**ADDENDUM NO. 1**

DATE: April 28, 2023

PROJECT: Lake Ouachita Water Supply Project
Contract B2 – Finished Water Transmission Pipeline
Hot Springs, ArkansasBID DATE: May 8th, 2023 at 1:00 PM

WATERTIGHT PIPE ENCASEMENT

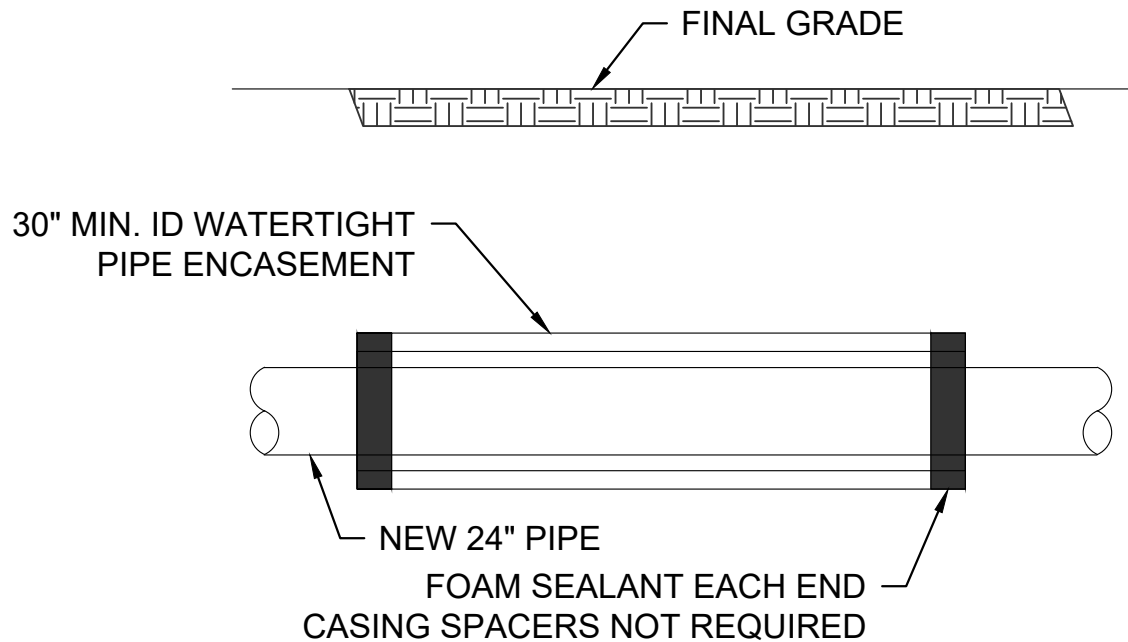
Item No. 5. Drawing Sheet 23 (not attached)

- a. Revise Detail E – “HDPE Encasement” as attached.
- b. Revise Detail D – For non-bevel geared valves the concrete support is to be a minimum of the width of the valve (flange to flange) + 12 inches square. For beveled geared valves (laying on their sides) the size of the concrete support is to be the width of the valve (flange to flange) + 12 inches x the total height of the valve.
